Town of Acton

In the **COLONIAL ACRES IV SUBDIVISION**

**To:** Planning Board **Date:** February 23, 2007  
**From:** Roland Bartl, AICP, Town Planner *RB*  
**Subject:** Colonial Acres IV – Squirrel Hill & Marian Road Street Acceptance

**Subject:** Semi-Final Inspection – Colonial Acres IV - Squirrel Hill Road and Marian Road

RELOCATED DRAIN EASEMENT E.J.A. 19  
 RECORD OWNER: ACTON ESTATES LLC  
 DATE: 10/12/2004 SCALE: 1" = 40'  
 INLAND SURVEY, INC. DBA  
**ZANGA LAND SURVEYING**  
 16 GLEASONDALE ROAD, SUITE 1-2  
 STON, MASSACHUSETTS 01775  
 (978)461-2355 FAX:(978)461-2351  
 (Z)1417E019.2D/1417.CRD

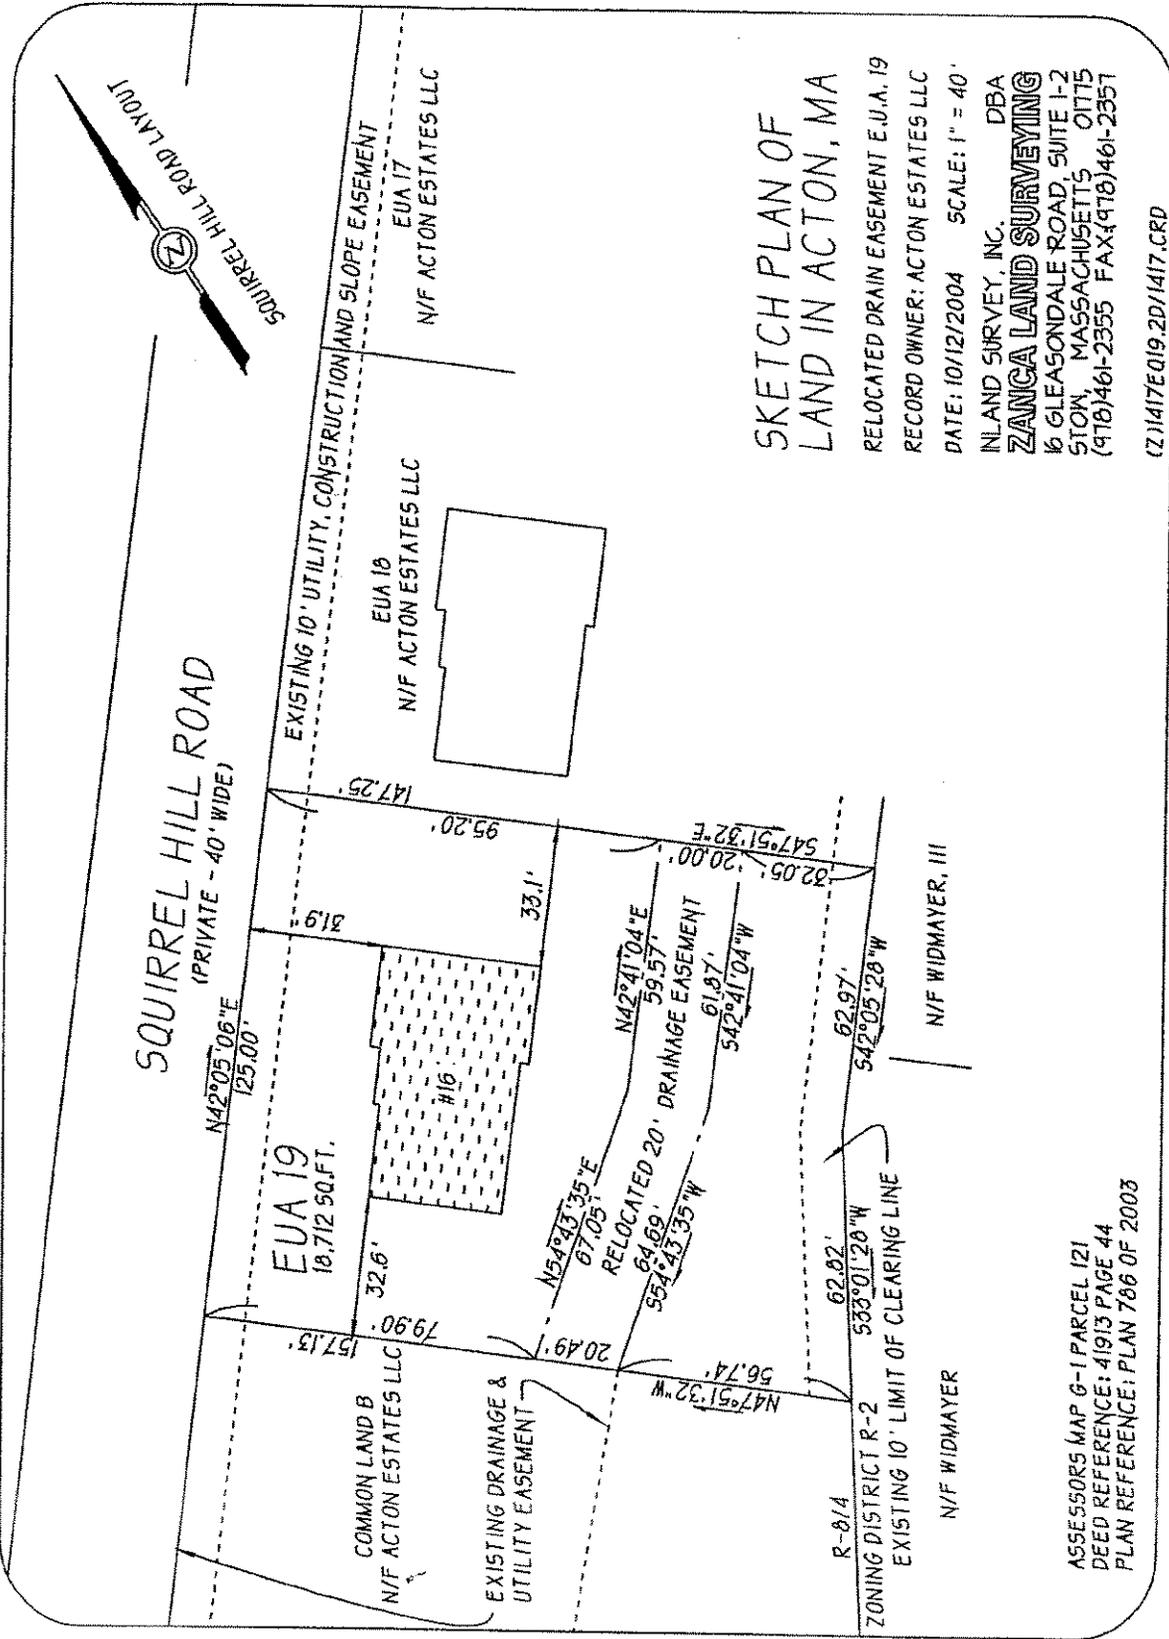
5. The 20 foot wide private drain easement located behind the existing dwellings on EUA 14, 15, 16 & 19 was apparently relocated during construction. Attached is a copy of the sketch plans showing the revised locations. The developer needs to submit the documentation to show that these revised easements have been recorded at the Registry of Deeds.
